DRC - PRELIMINARY
4.7.2016

HEARST GARDENS

Planning and Development Department
Land Use Planning Division

Re: Use Permit #ZP2016-0028 – 1155-1173 Hearst Avenue

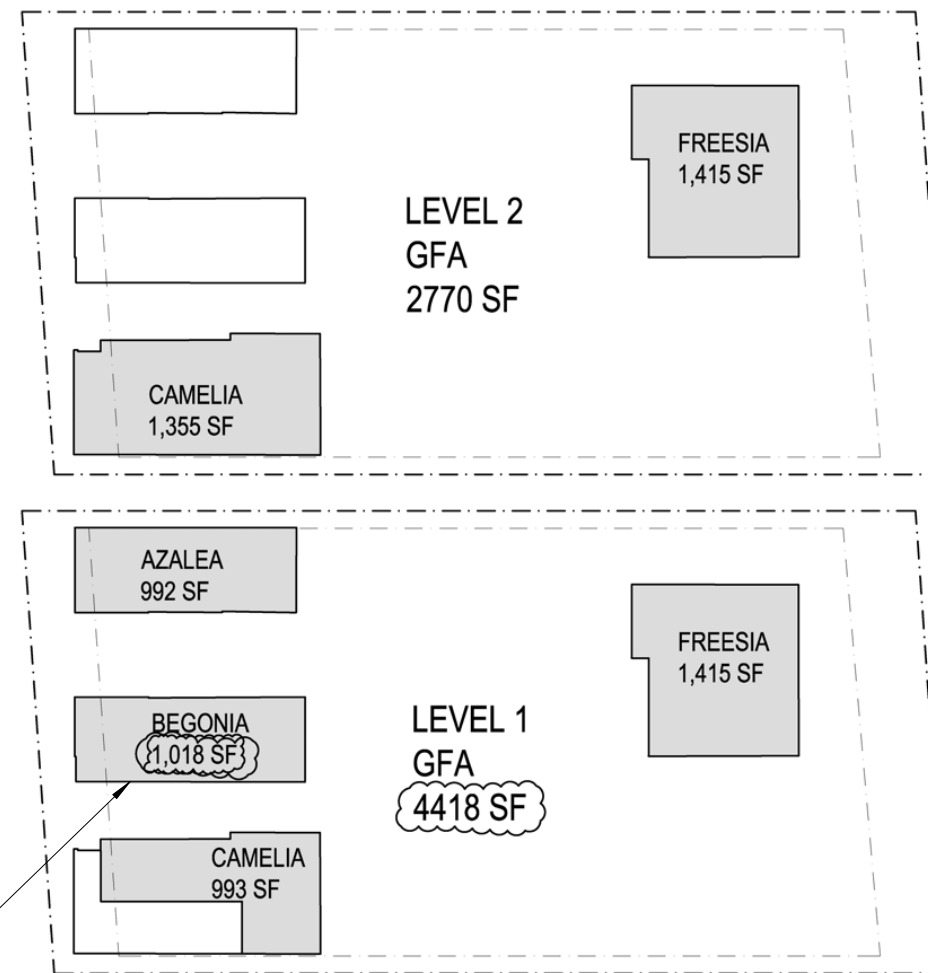
RECONCILED DISCREPANCY IN EXISTING BEGONIA FOOTPRINT. TOTAL PREVIOUSLY SHOWN AS 1132 SF, CORRECTED TO BE 1,018 SF (A DIFFERENCE OF 114 SF). THE CHANGES IN THE TABLE ABOVE ARE ALSO DUE TO THIS CORRECTION.

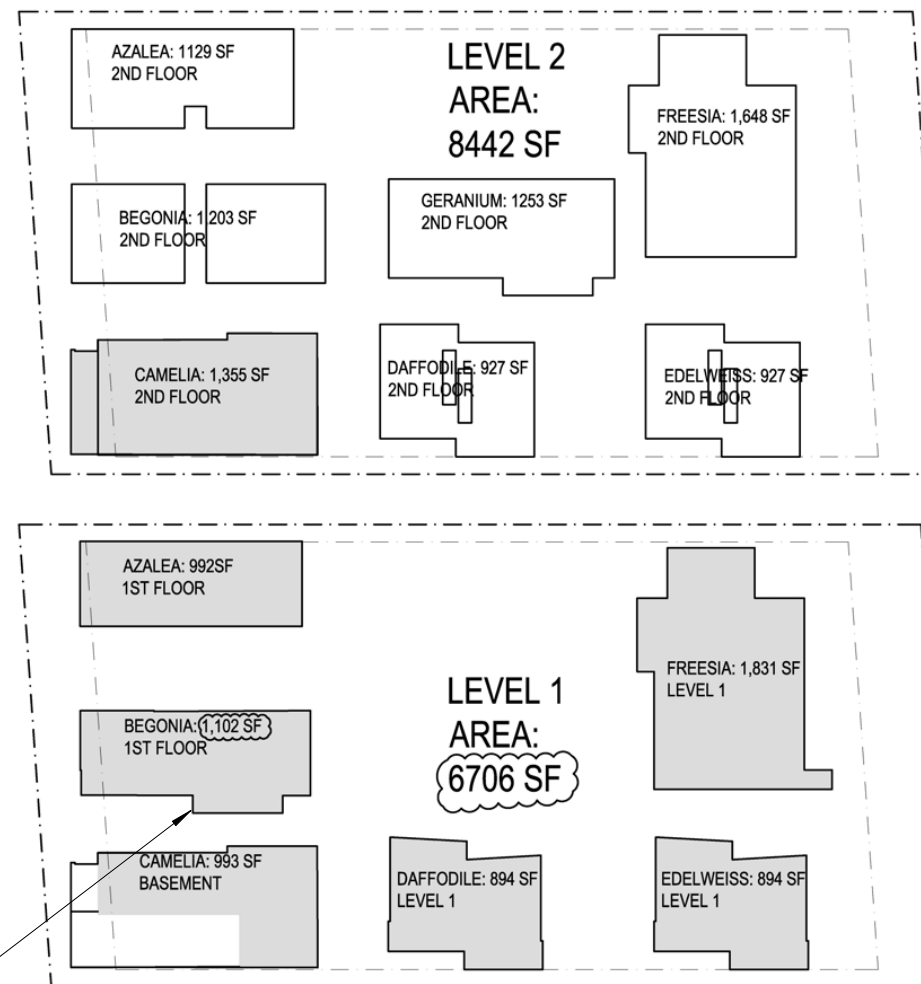
ACCESS STAIR MOVED TO THE EAST SIDE OF THE BEGONIA BUILDING, WHICH PROVIDES ROOM FOR A LARGER ACCESSIBLE PARKING OFFLOAD ZONE (SEE SHEET A1.5 FOR FURTHER DETAIL). THIS CHANGE RESULTS IN A SLIGHT REDUCTION IN GROSS FLOOR AREA FOR THIS BUILDING (30 SF LESS THAN THE 1132 PREVIOUSLY SHOWN). ALL NUMERICAL CHANGES ON THIS SHEET ARE DUE TO THIS CHANGE IN STAIR LOCATION.

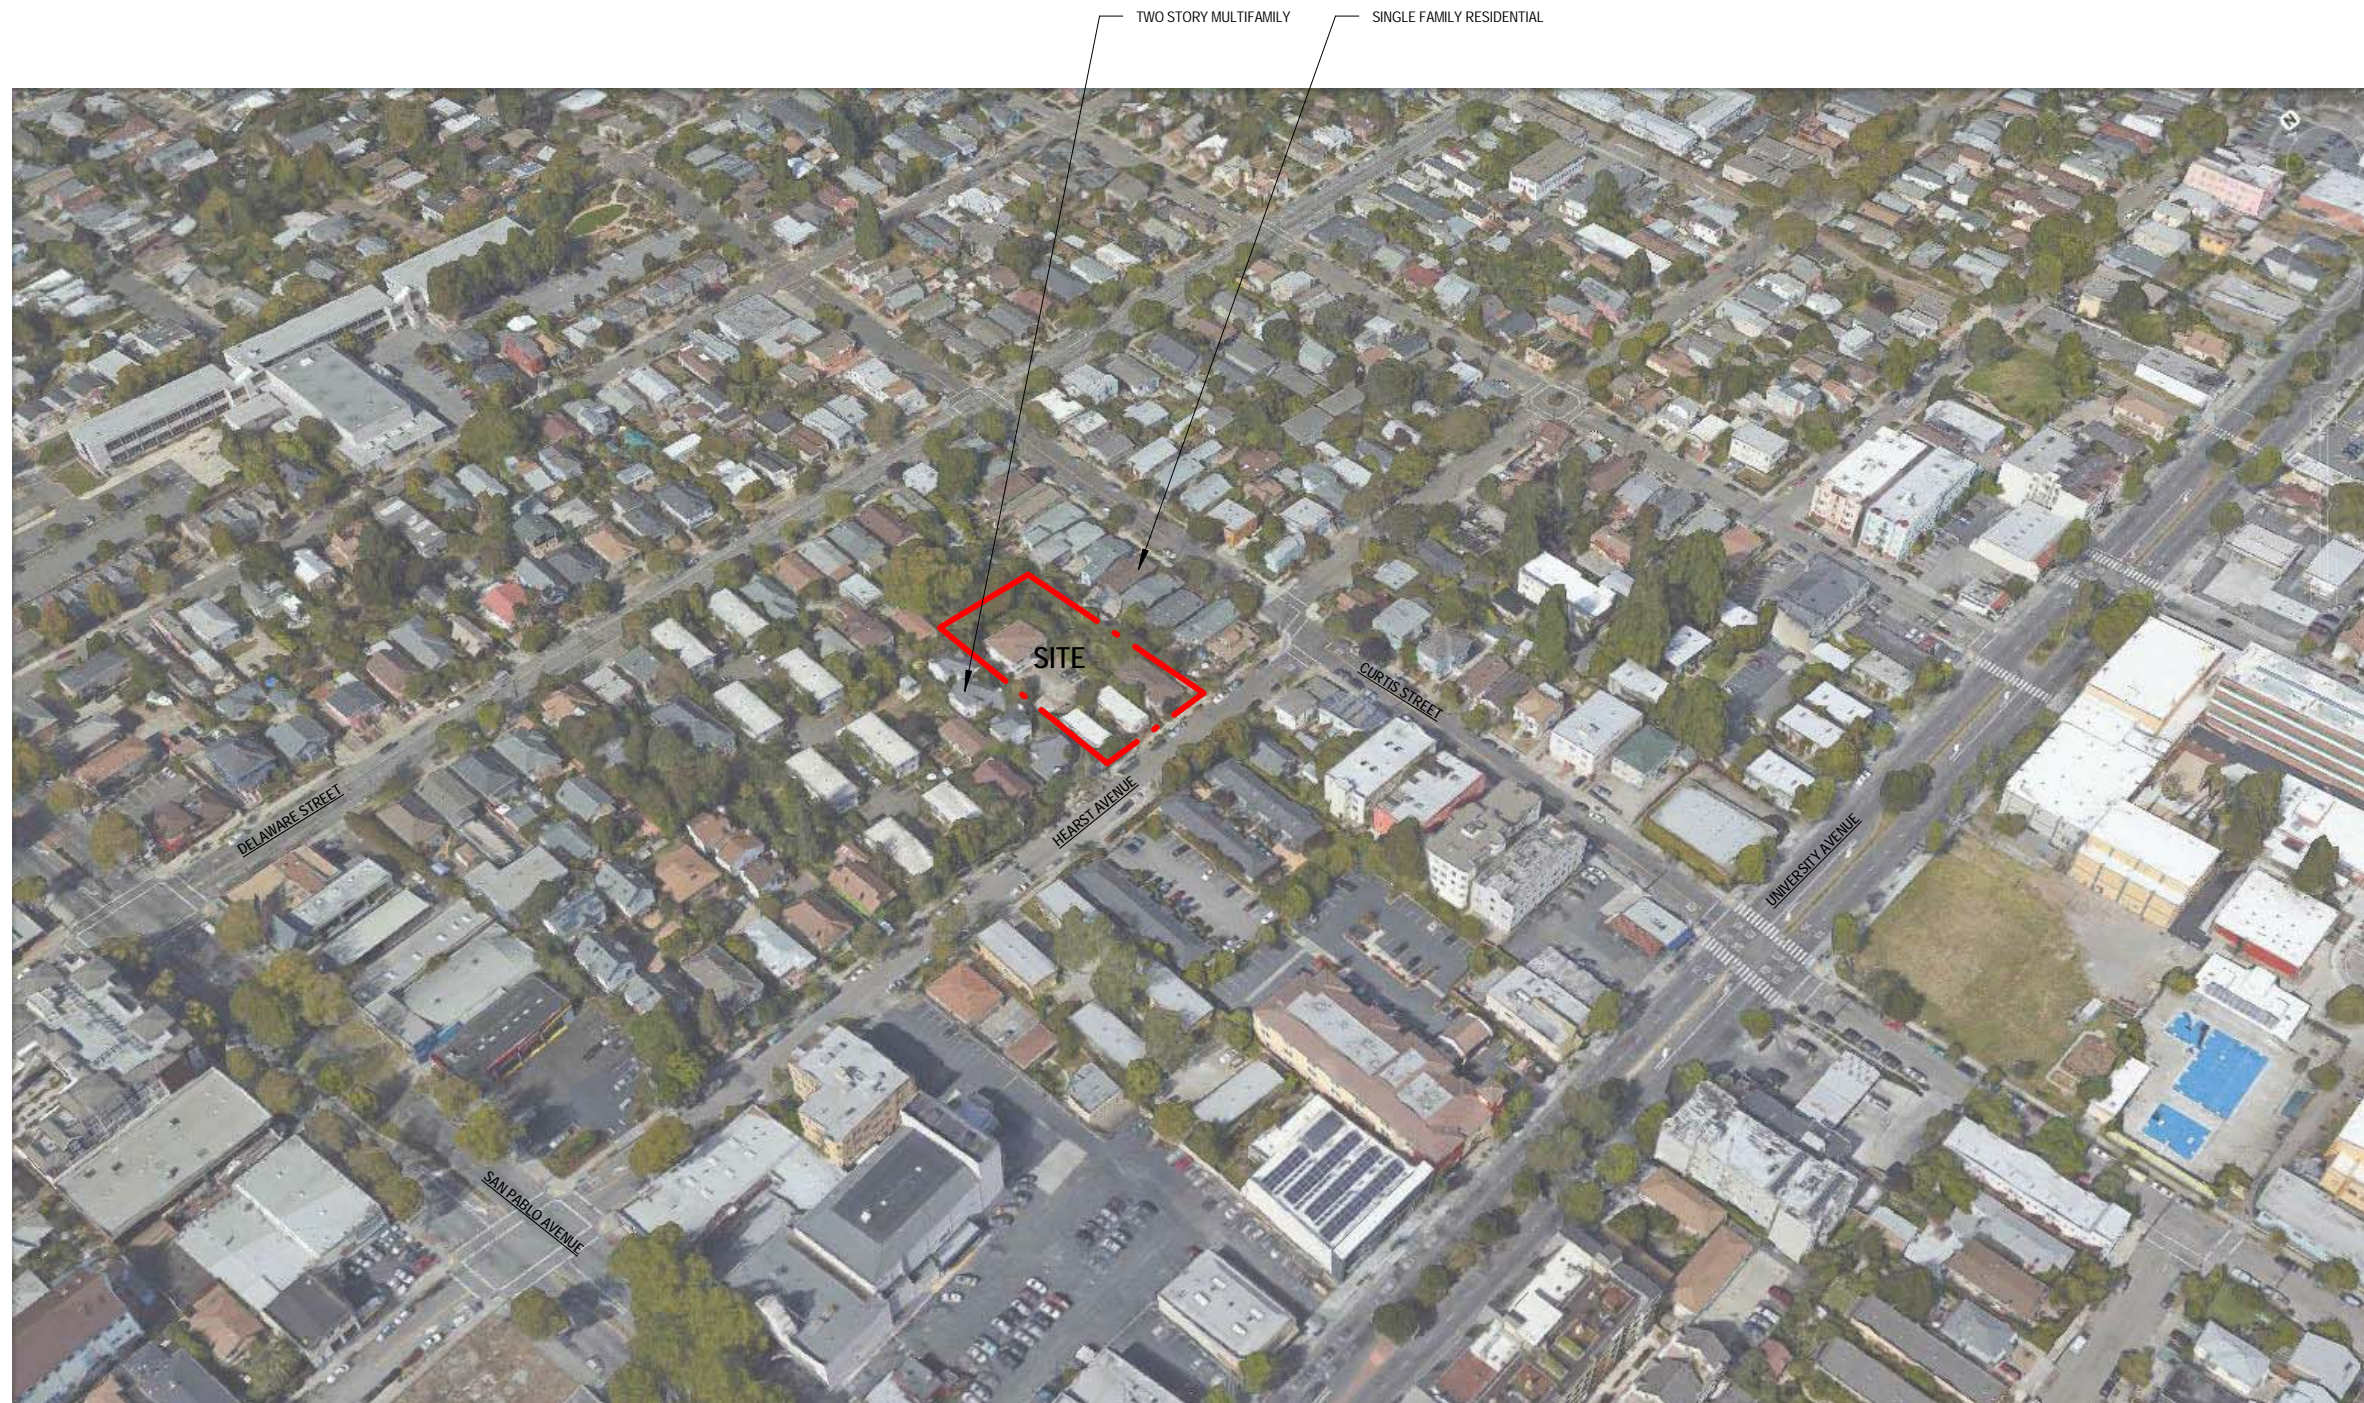
ACCESS STAIR MOVED TO THE EAST SIDE OF THE BEGONIA BUILDING, WHICH PROVIDES ROOM FOR A LARGER ACCESSIBLE PARKING OFFLOAD ZONE (SEE SHEET A1.5 FOR FURTHER DETAIL). THIS CHANGE RESULTS IN A SLIGHT REDUCTION IN GROSS FLOOR AREA FOR THIS BUILDING (30 SF LESS THAN THE 1132 PREVIOUSLY SHOWN). ALL NUMERICAL CHANGES ON THIS SHEET ARE DUE TO THIS CHANGE IN STAIR LOCATION.
